HYUNDAI Technical Service Bulletin

Group	ENGINE MECHANICAL
Number	01-20-002-1
Date	OCTOBER, 2001
Model	2001 2.4L SONATA/SANTA FE

**2001 SONATA / SANTA FE 2.4L ENGINE
RUNS ROUGH, IDLES ROUGH, DTC P0335**

This TSB has been revised to add a procedure to index the oil pump / balance shaft sprocket. Not properly indexing the sprocket may cause an engine vibration, mostly noticed at 3500-4000 rpm. The warranty information table has also been changed.

Location of the timing belt guide.

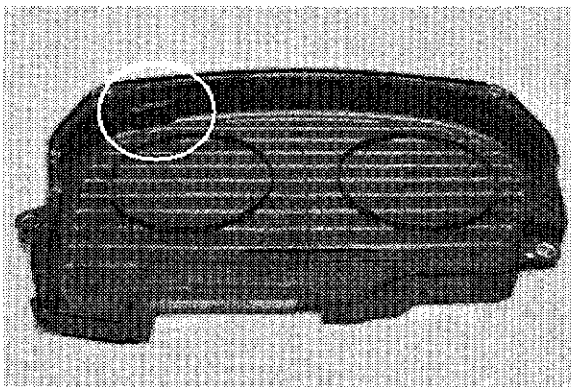
A new timing belt cover P/N 21360-38214-D that incorporates a timing belt guide has been installed on vehicles produced since January 30, 2001.

Vehicles that experience the condition described above should be updated with the new timing belt cover

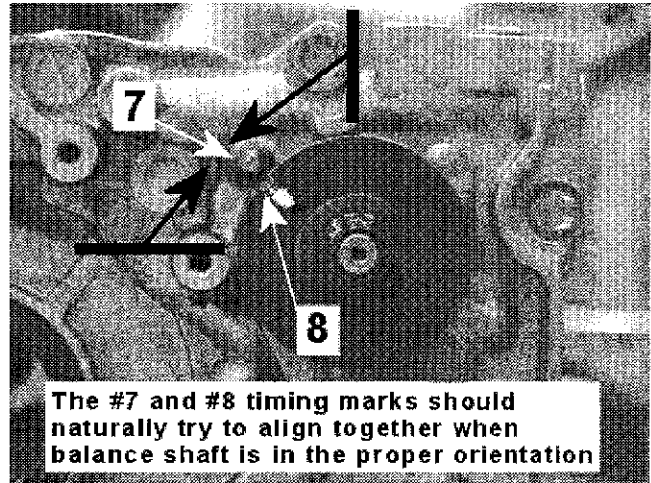
8. Set the oil pump sprocket so that timing marks #7 and #8 are aligned. Quickly rotate the sprocket back and forth, between the 9 and 12 o'clock position "feeling" for a "centering feel" when the timing marks meet. If the sprocket timing mark feels like it wants to move away from the other mark, rotate the sprocket one complete revolution and try it again.

Timing marks #7 and #8 will naturally align when the balance shaft is in the proper orientation.

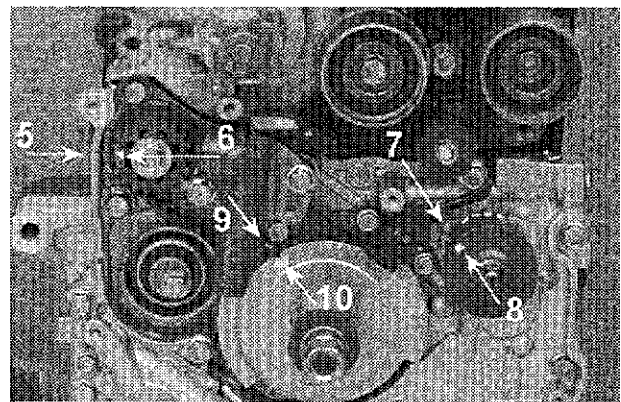
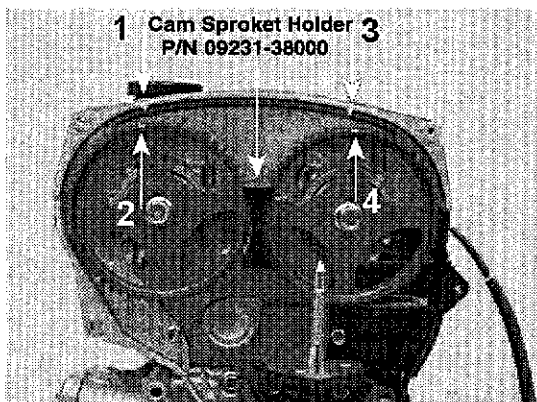
9. Verify the following timing marks are aligned (refer to photos below):
- a. Camshaft sprockets (intake 1, 2; exhaust 3, 4)
 - b. Balance shaft (5, 6) and oil pump sprocket/balance shaft (7, 8)
 - c. Crankshaft (9, 10)
